Bulletin

SUBJECT: Safetran Base Control Module (BCM), 53408

NO: 4-02

CONCERN: Improved Reliability of RSSI Function to Prevent A-to-D Converter Lockup

Figure 1. Hardware Revision Identification

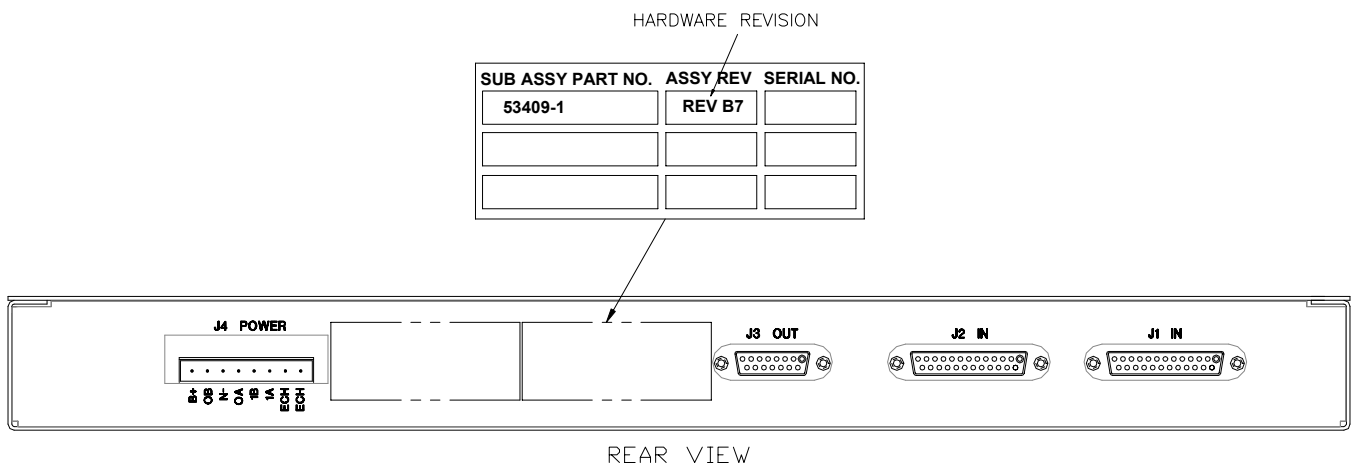
Early versions of Safetran’s Base Control Module (BCM), part number 53408, showed a tendency for the A-to-D converter circuitry to lock up and disable the receive signal strength indication (RSSI) function. This problem was corrected by a minor hardware update and a software change on the 53409 module contained in the 53408.

Updated hardware is identified by revision B7 or later on the sub-assembly label located at the back of the BCM case (see figure 1). Updated hardware **MUST** have software version 406W or later installed to correct the problem.

If hardware is revision B6 or earlier, return it to Safetran for update to the current revision. Safetran will update units returned within 2 years from the date of this bulletin without charge. Units returned after the 2-year period will incur a nominal repair charge.
